RESOLUTION NO. R16-117

A RESOLUTION AUTHORIZING THE MAYOR TO SIGN
CHANGE ORDER NO. 7 WITH WILSON BROTHERS CONSTRUCTION
FOR THE WATER TREATMENT PLANT INTAKE PROJECT *JW NW TMM*
CONSTITUTING AN INCREASE OF ~~\$76,549.70~~ \$75,591.75

Date of Issuance: December 6, 2016	Effective Date:	December 6, 2016
Owner: City of Laurel, Montana	Owner's Contract No.:	FEMA: 1996-DR-MT-PW 01679
		SRF: EQ 16-1684
Contractor: Wilson Bros. Construction, Inc.	Contractor's Project No.:	MT16-04
Engineer: Great West Engineering, Inc.	Engineer's Project No.:	2-07128-TO26
Project: Water Treatment Plant Intake	Contract Name:	N/A

Schedule of Work Items for Change Order No. 7: Hot Water Flush Tank/Pump

CITY OF LAUREL, MONTANA
WATER TREATMENT PLANT INTAKE
BURIED WATER STORAGE TANK
DETAILS AND SECTIONS

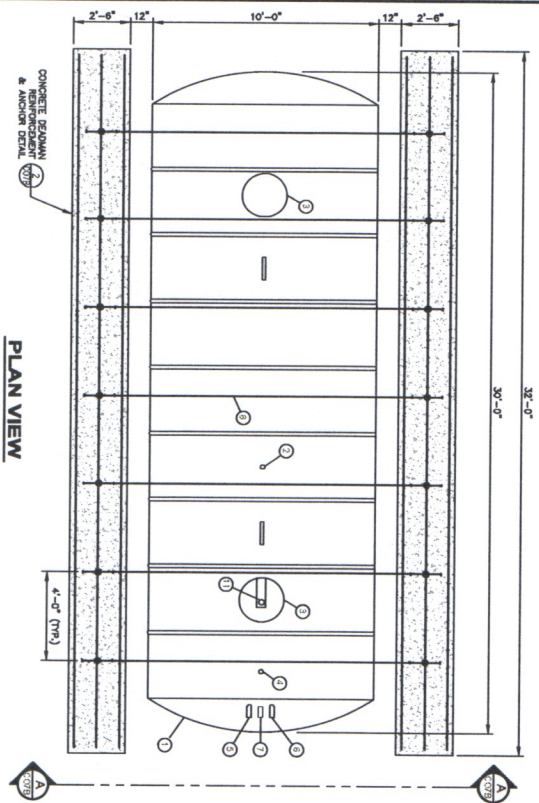
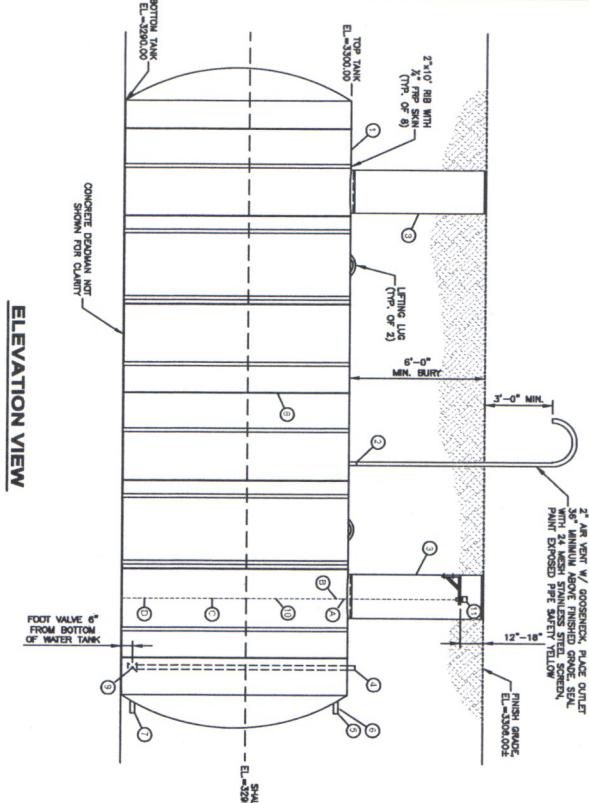
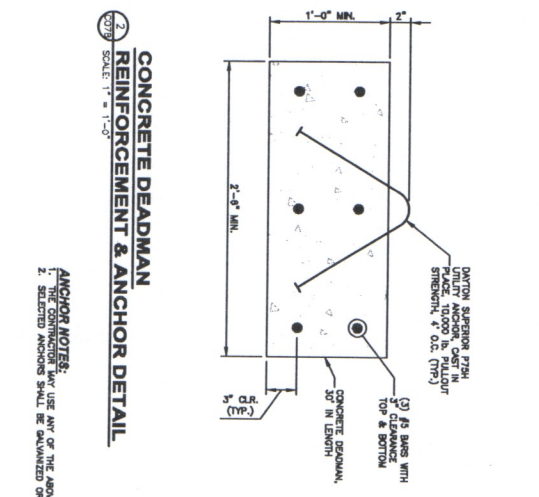
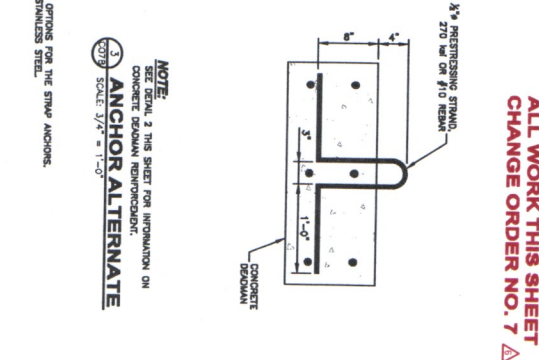
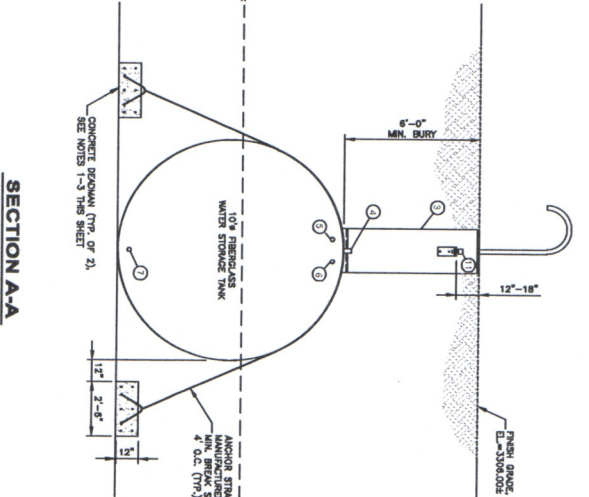
This Change Order is for work associated with installing an alternate water supply for the hot water flush system for the intake, which is used for frazil ice mitigation. The hot water flush system was designed to be supplied with a groundwater well. However, when a well was drilled near the control building, bedrock was encountered at a depth of ten feet, and the well yield was insufficient to supply the hot water flush system. The alternate system will pump water from one of the transmission mains to a storage tank located at the control building. The water will then be pumped from the tank to the boiler and then out to the intake. The details of the alternate system are shown in the attached plans, specifications and itemized cost breakdown from the Contractor.

ALL WORK THIS SHEET CHANGE ORDER NO. 7

CONCRETE DEADMAN REINFORCEMENT:
1. 2x10" RIBS WITH 3/4" REBAR SKIN (TYP. OF 8) TOP & BOTTOM
2. 1/2" REBAR SKIN (TYP. OF 2)
3. 3/4" AIR VENT WITH GOOSE-NECK, 3/4" PIPE, 3/4" STAINLESS STEEL SCREEN, 3/4" MESH ABOVE FINISHED GRADE SURF.
4. 6" FOOT VALVE AT BOTTOM OF WATER TANK.

SECTION A-A:
1. 10" FIBERGLASS WATER STORAGE TANK
2. 3/4" AIR VENT WITH GOOSE-NECK, 3/4" PIPE, 3/4" STAINLESS STEEL SCREEN, 3/4" MESH ABOVE FINISHED GRADE SURF.
3. 6" FOOT VALVE AT BOTTOM OF WATER TANK.

GENERAL NOTES:
1. PROVIDE TWO (2) 3/4" PREPACKAGED ANCHORS FOR EACH CONCRETE DEADMAN (FOUR TOTAL) WITH ADDRESS TO EACH ANCHOR STRAP AND CONCRETE ANCHOR.

BOOSTER PUMP AT TRANSMISSION MAIN

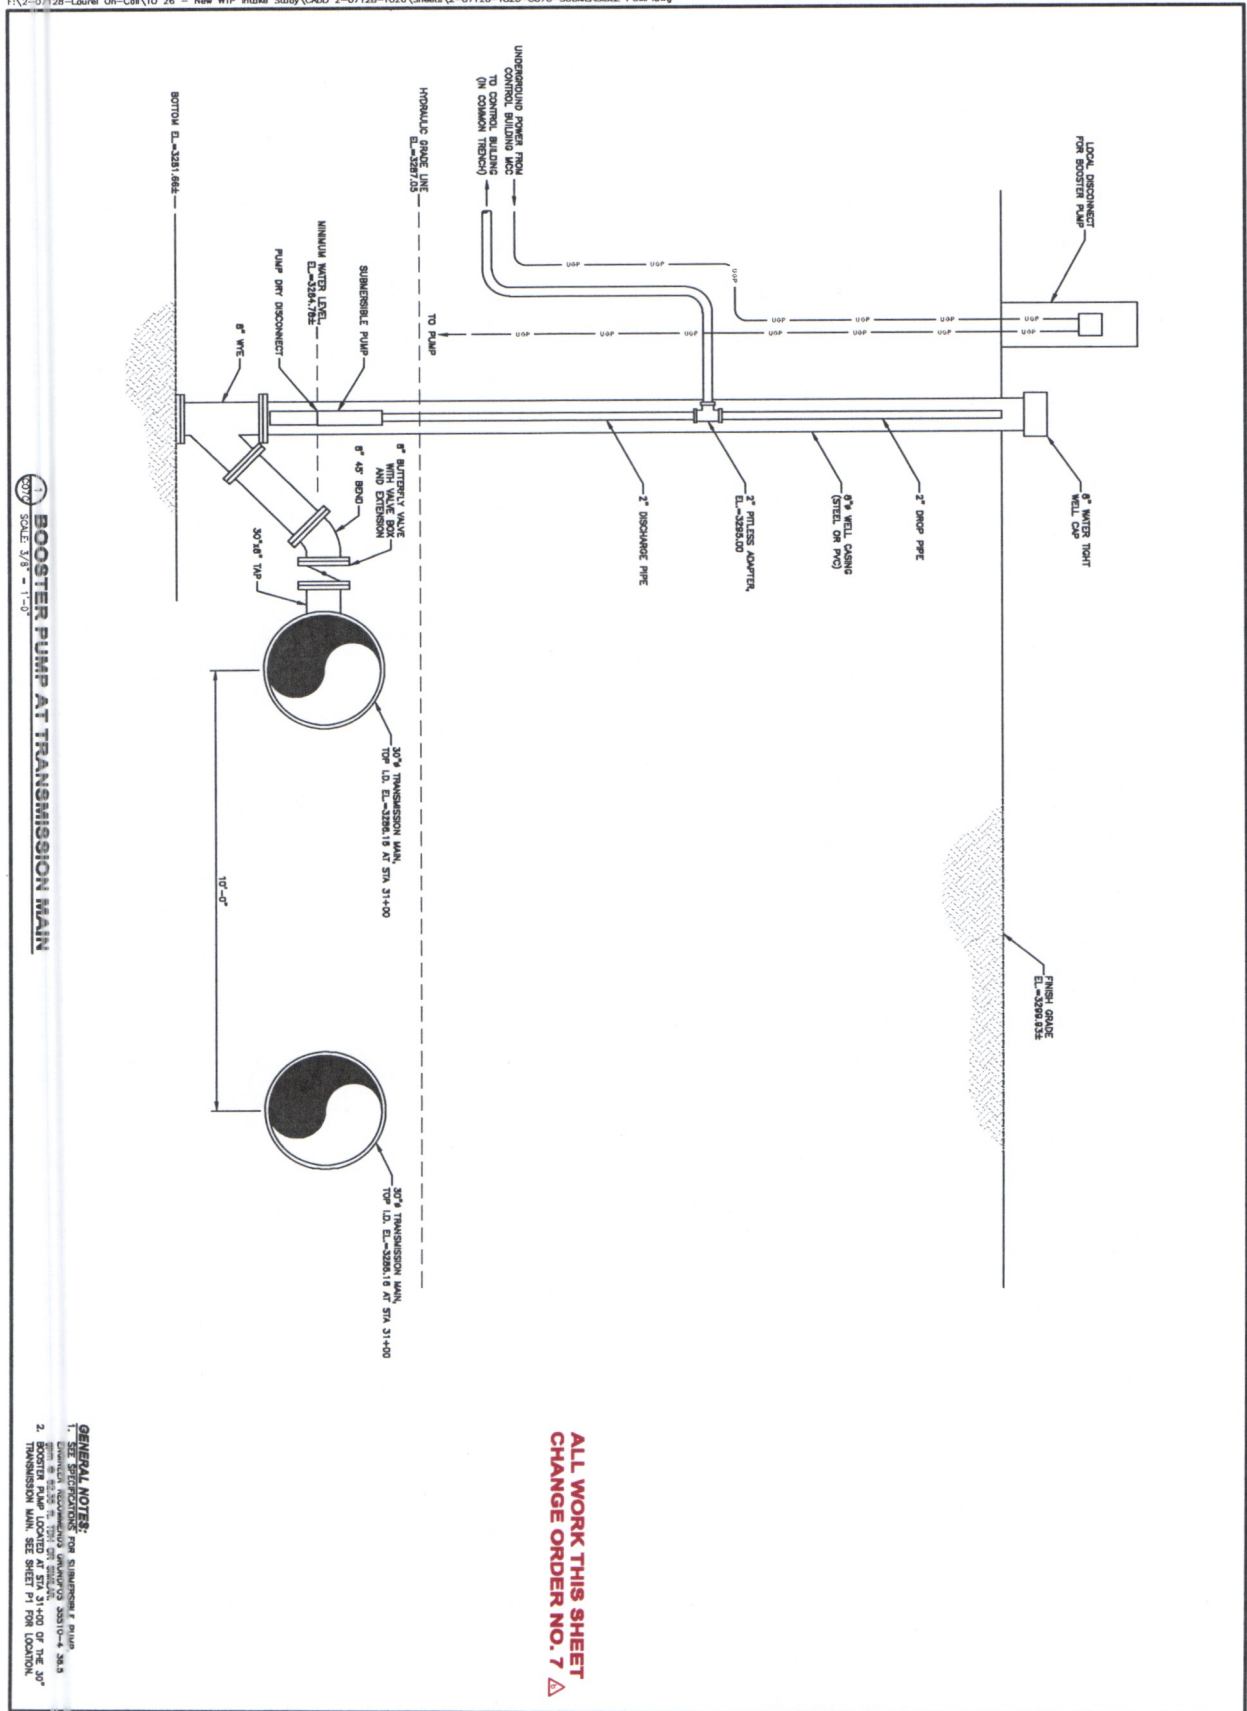
**ALL WORK THIS SHEET
CHANGE ORDER NO. 7**

GENERAL NOTES:
 1. SEE SHEET C07C FOR SUBMERSIBLE PUMP
 2. BOOSTER PUMP LOCATED AT STA 31+00 OF THE 30\"/>

1 ONE-LINE DIAGRAM
E.3 CONTROL BUILDING N.T.S.

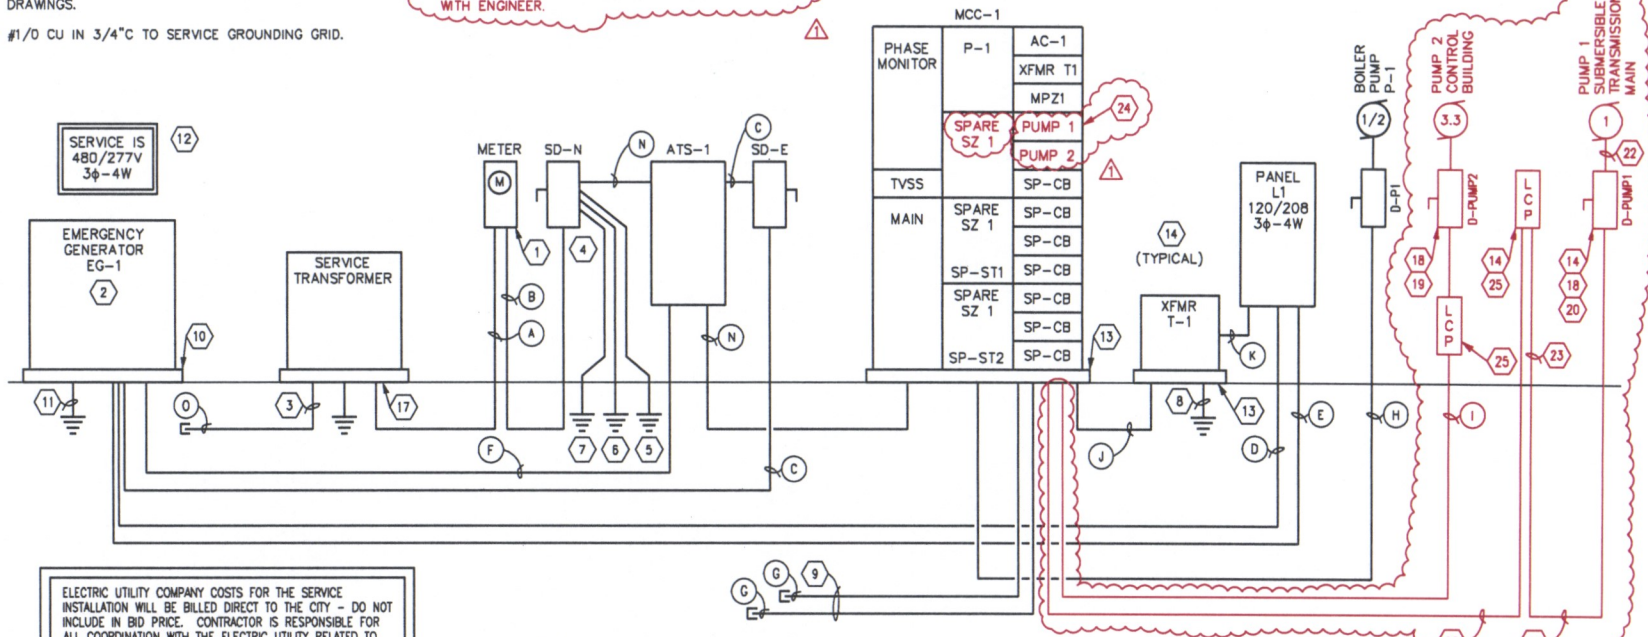
BY DATE: [] [] [] []
REVISION DESCRIPTION: [] [] [] []
CHANGE ORDER NO. 7
PROJECT: WATER TO 28
DESIGNED BY: []
DRAWN BY: []
CHECKED BY: []
APPROVED BY: []
DATE: APRIL 26, 2016

- 21 4-4-4-6 (THREE CONDUCTOR WITH GROUND) STABLY JACKETED METAL CLAD CABLE. ALUMINUM CONDUCTORS, ARMORED, DIRECT BURIAL WITH PVC JACKET, RATED AMPACITY 65 AMPS AT 75C. THE RUN SHALL BE CONTINUOUS FROM THE CONTROL BUILDING TO THE PUMP LOCATION WITHOUT SPLICES. ENOUGH EXCESS CABLE SHALL BE ORDERED TO ENSURE THAT SPLICES WILL NOT BE REQUIRED. INSTALL CABLE WITH ADEQUATE HORIZONTAL SEPARATION FROM PIPING TO ENSURE THAT THE CABLE WILL NOT BE DAMAGED IF A PIPE BREAK REQUIRES REPAIR.

- 22 3 #10 AND 1 #10 GRD IN 3/4" C
- 23 INSTALL JACKETED METAL CLAD CABLE IN 2-INCH CONDUIT, FROM THE PUMP MOTOR CONTROLLER IN THE CONTROL BUILDING TO APPROXIMATELY 10'-FEET PAST THE CONTROL BUILDING WALL. RGS CONDUIT SHALL BE USED WHERE EXPOSED IN THE BUILDING. SCHEDULE 80 PVC CONDUIT CAN BE USED FOR THE BELOW GRADE SECTION. INTENT IS TO PROVIDE A SLEEVE FOR THE CABLE ENTRANCE INTO THE BUILDING.

- 24 USE TWO (2) OF THE SPARE 20A/3P CIRCUIT BREAKERS IN MCC-1 TO FEED THE TWO NEW PUMPS, PUMP 1 AND PUMP 2.
- 25 MOTOR CONTROLLER IS PROVIDED WITH PUMP. INSTALL MOTOR CONTROLLER IN CONTROL BUILDING, IN LOCATION AS DEFINED BY ENGINEER.
